## Department of Energy

SUBJECT: Submittal of the Fort Saint Vrain (Docket 72-9) Safety Analysis Update Report  
72-9/2015-01, SNM-2504 (EM-FMDP-15-032)

## Update Report 72-9/2015-01

Figure 9.1-1 DOE-ID Organization

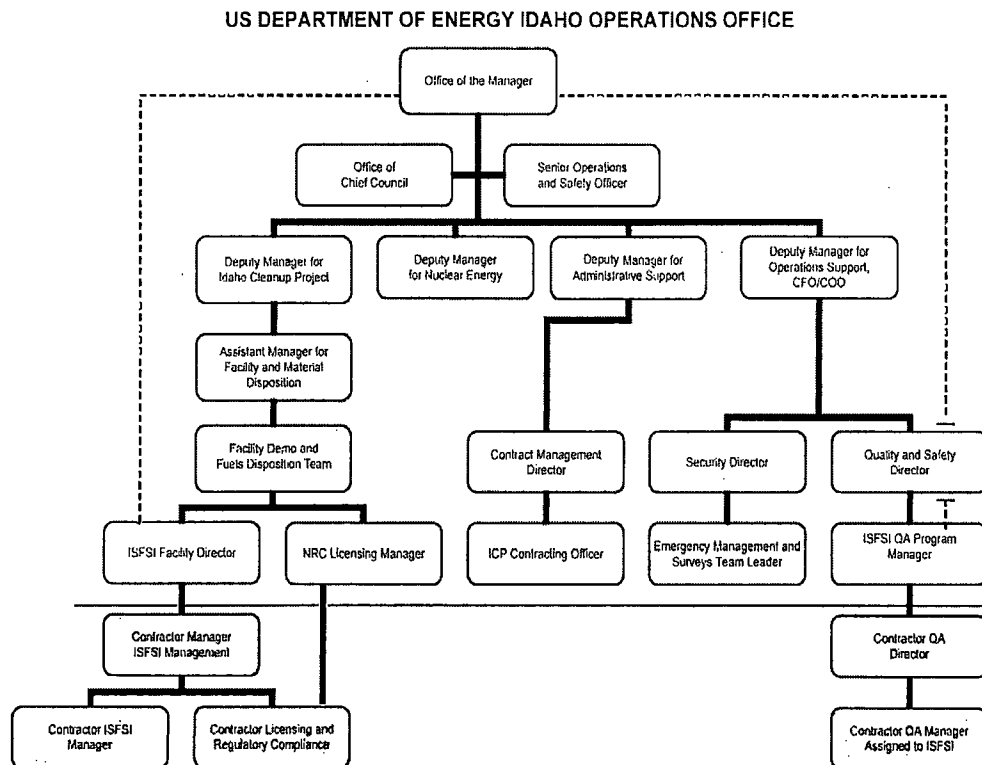
- Figure 9.1-1, DOE-ID Organization was revised to reflect DOE-ID position title changes.
- A position title change was also reflected in a revision to Section 11.1.3 along with minor format and footer changes.
